工程指示 / 要求簡箋 ENGINEER INSTRUCTIONS (E.I.)

工程指示編號:	EI- 4614	修改版本:	-
	HK- 666		
工程編號:	J 852	工程名稱:	亞皆老街中電
收件人:	生統	發件人:	Karina Lee
工程項目:	趟門框 地盤用鋁角 T1-T3 : 1-23/F (67*35*2mm) (71*35*2mm) 連石塊角	日期:	14/04/2022

Submission of Proposal of Method Statement for Additional Water Drain Hole for Sliding Door (MST072)

Project : Proposed Residential Development at 139-147 Argyle Street,
Kowloon (J3860)

請參考附圖2

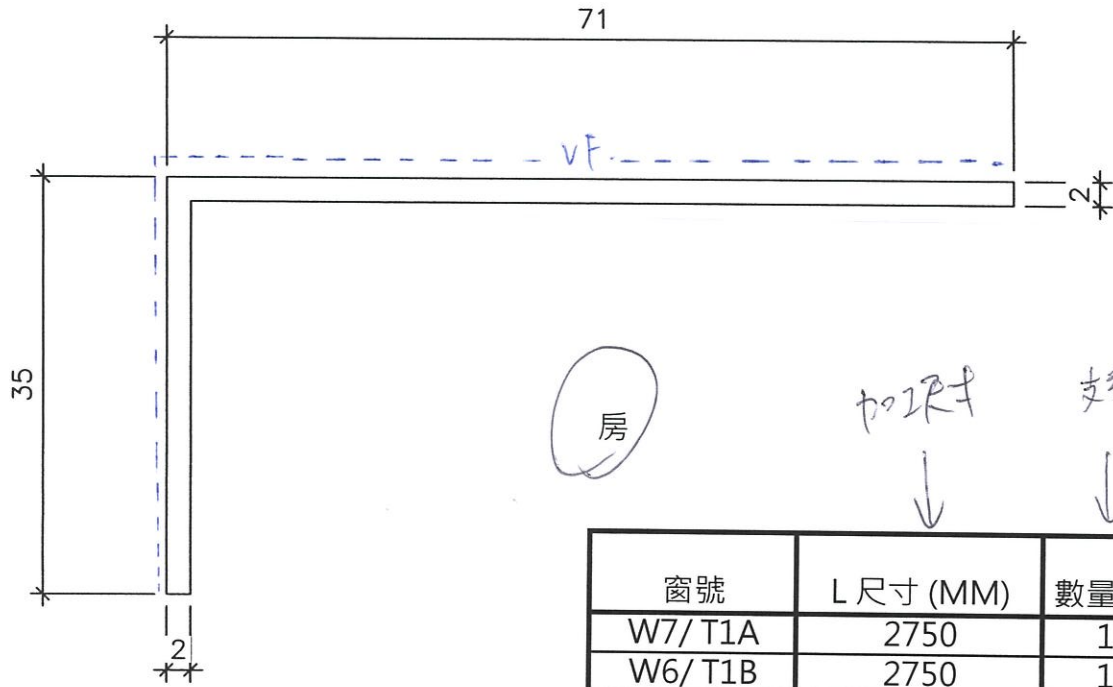
內容: 由於趟門框開去水孔, T1-T3 : 1-23/F 趟門框, 需要鋁角遮去水孔。
E14529已做樣板+在現場已試安裝。
廳: 左右2邊鋁角長度需預長125mm用作界避位用 (只限有門中企至門中企)
房: 鋁角長度需預長50mm
鋁料請貼上窗號。
謝謝

材料: 2mm 厚鋁角

加口位置補油

加口位置補油
 ↓ ↓ ↓ ↓ ↓ ↓
 加口位置補油

房

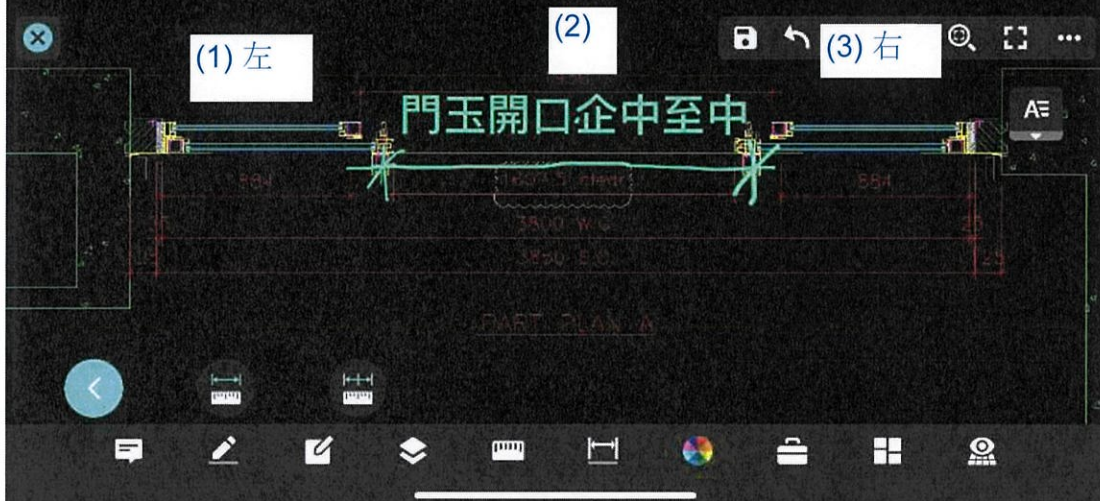
材料= 2mm厚鋁角
 加位補油

加尺寸 支數
 ↓ ↓

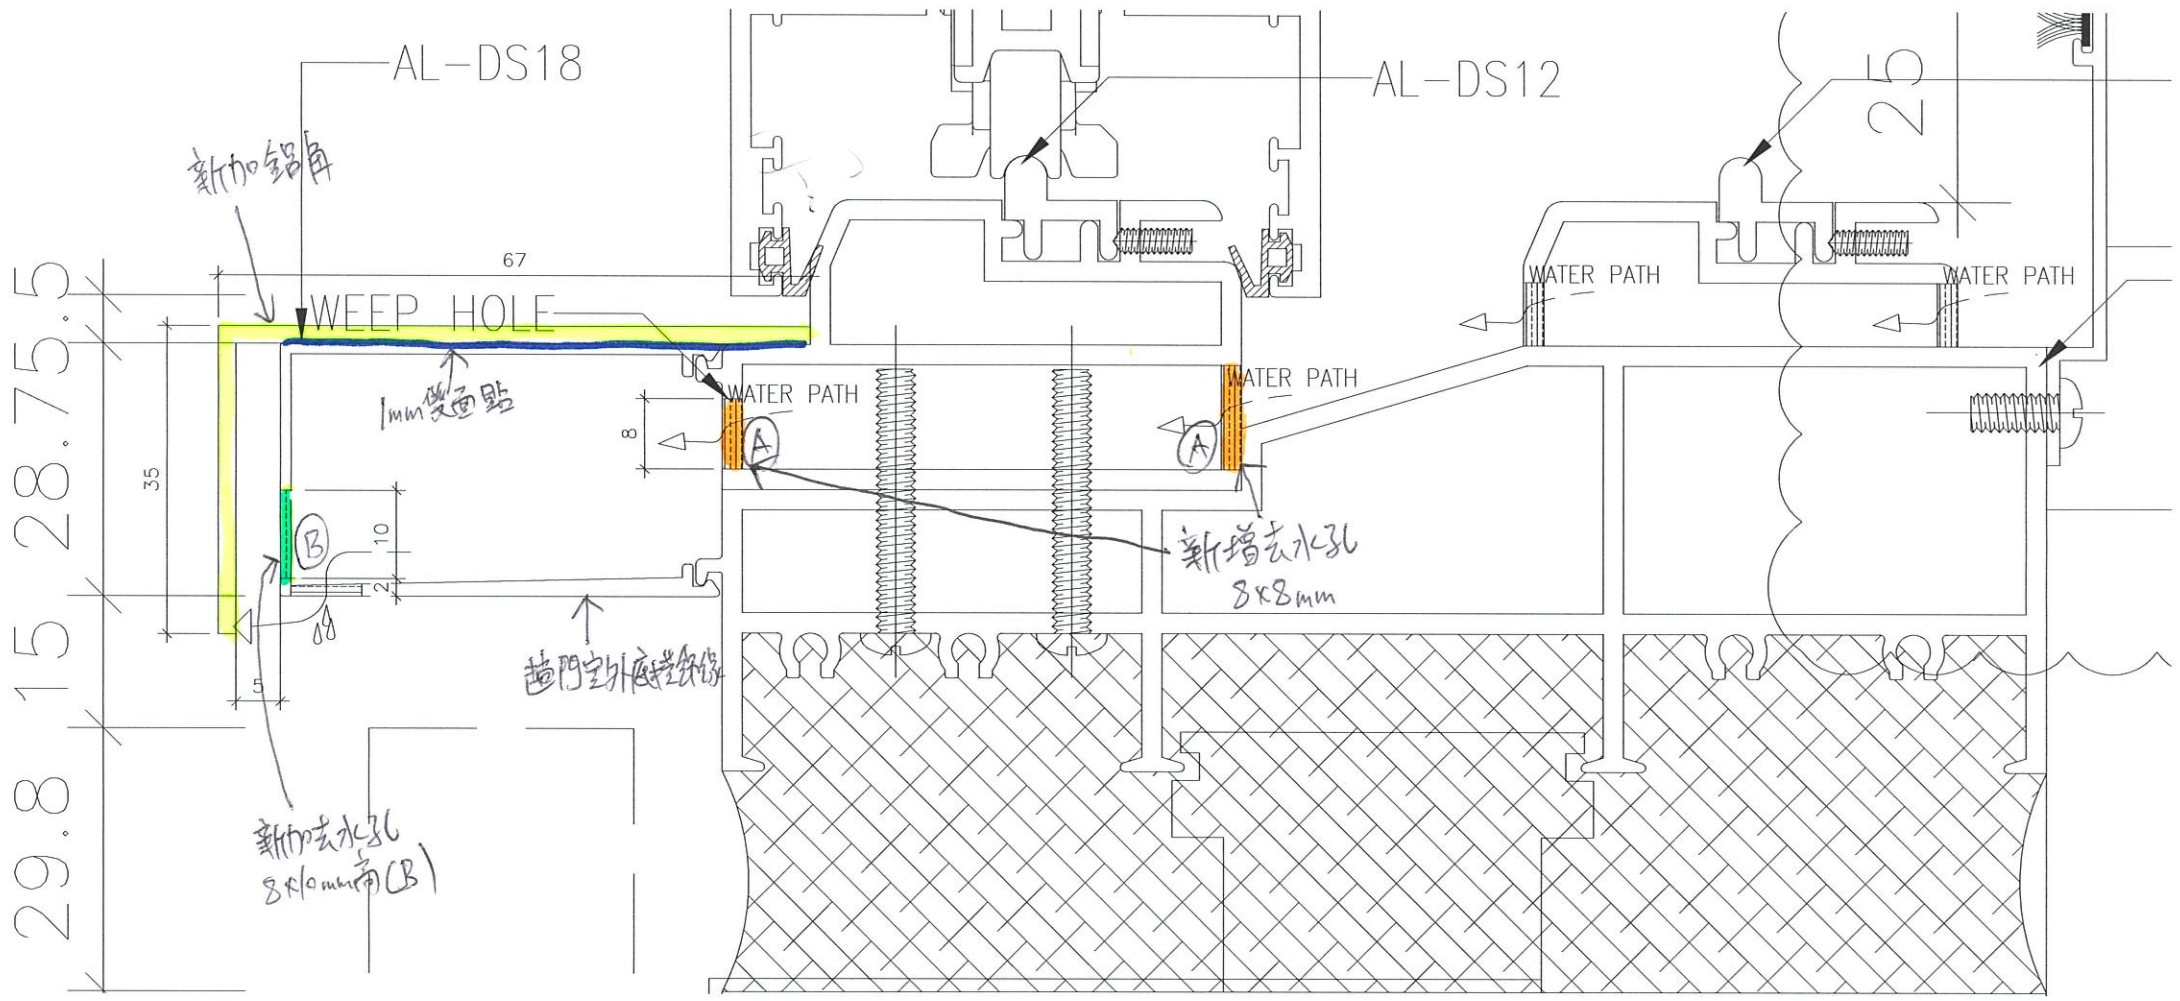
樣板層趟門試水後發現去水量不足，需加開去水孔

- 1) 現場拆除室外趟門底橫向收口
- 2) 在趟門框加開 8x8mm 長去水孔(A)，分二/三/四趟(見附圖及開孔位置)
- 3) 在趟門室外底橫飾線上加開 10x8mm 長去水孔(B)，分二/三/四趟(見附圖及開孔位置)
- 4) 增加鋁角在原趟門底橫向收口上，鋁角離底橫收口 5mm，以供足夠空間作去水用

(A) 門框內
新增 8x8mm 去水孔

(B) 牆門外底橫飾線
新增 8x10mm 高去水孔

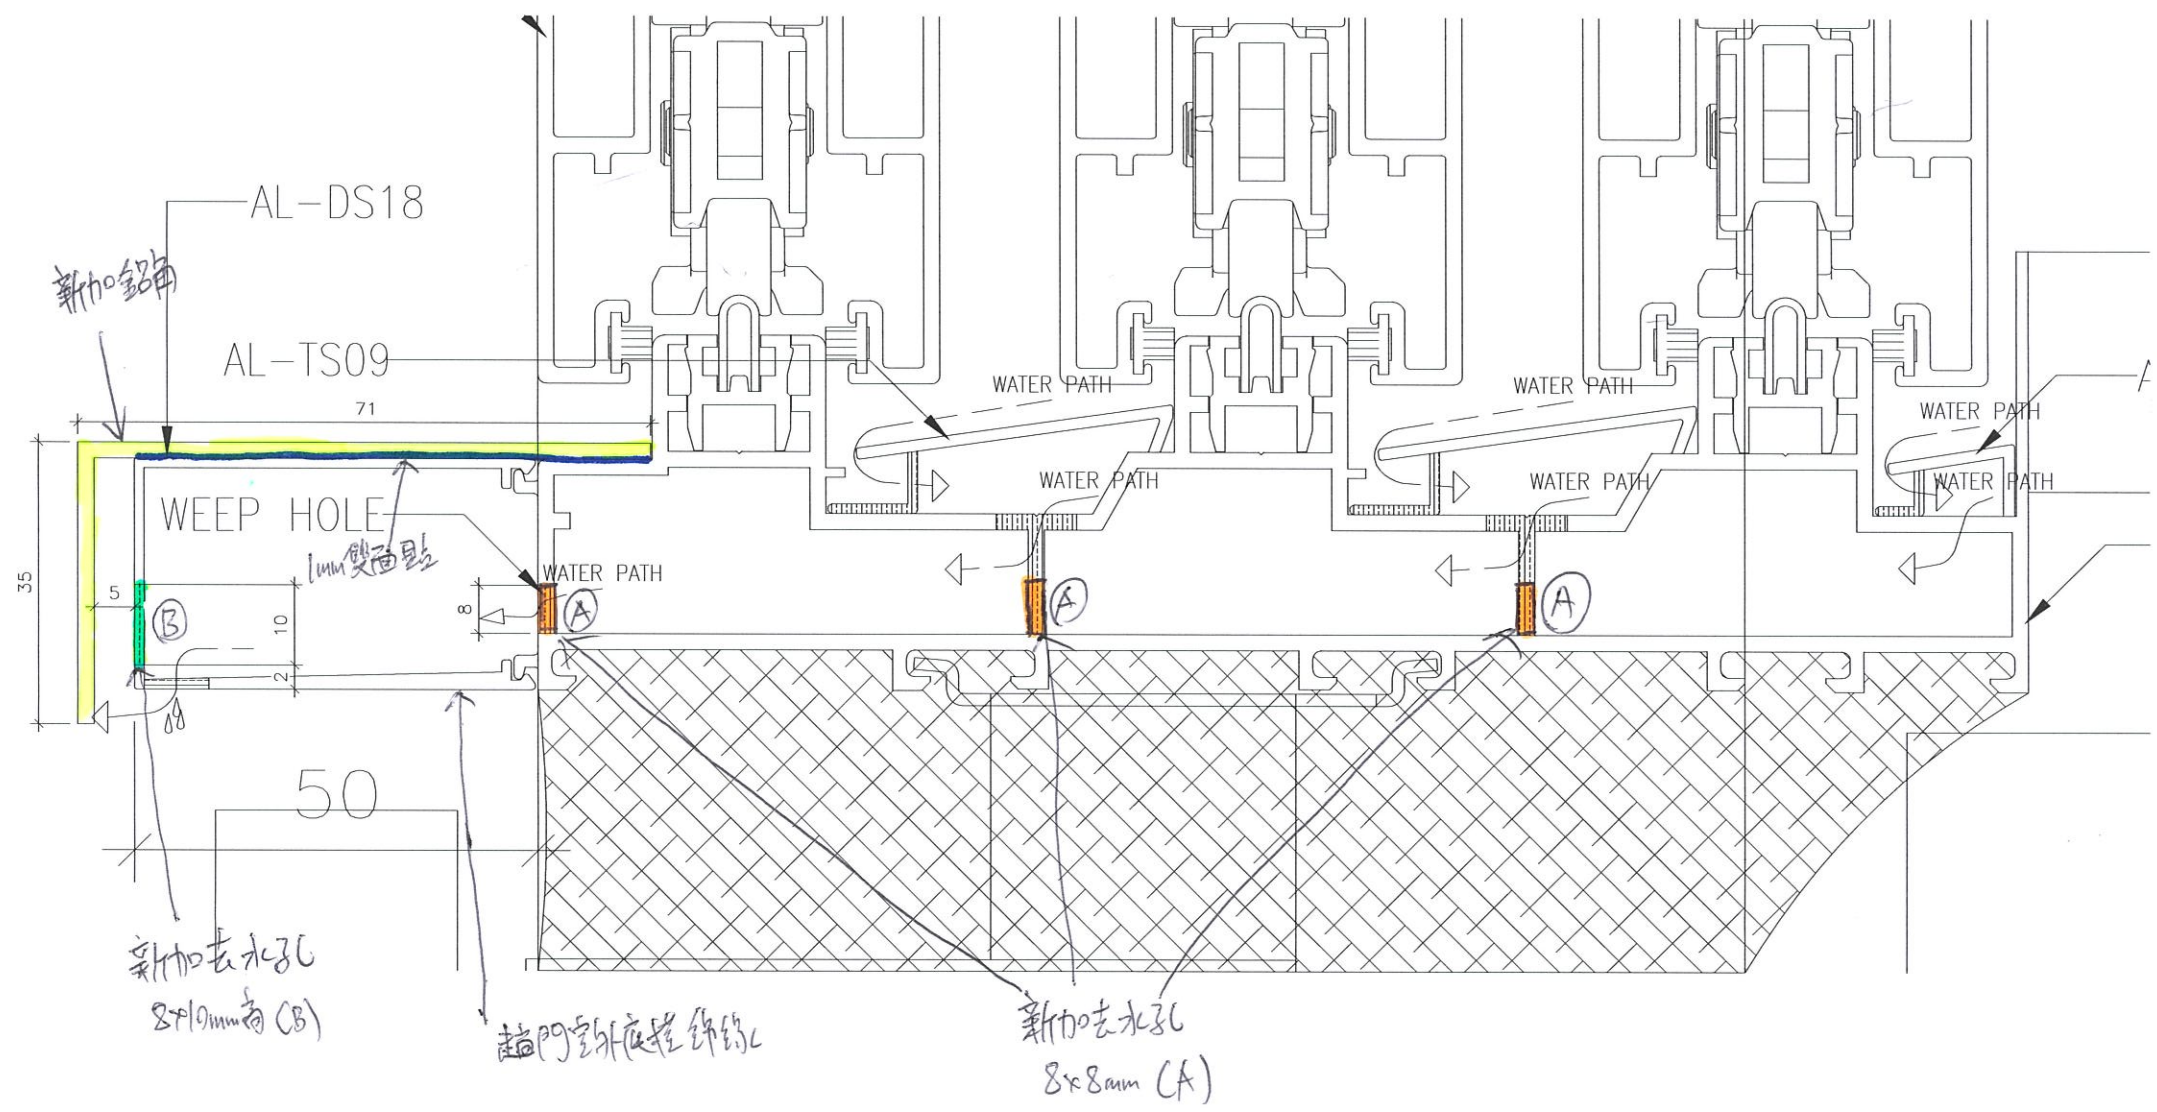
- (A) 門框內
新增 8x8mm 去水孔
- (B) 窗門室外底橫飾線
新增 8x10mm 高去水孔

門框內新增 8x8 mm 去孔 (A)
插門室外底接卸線新增 8x10 高去孔 (B)
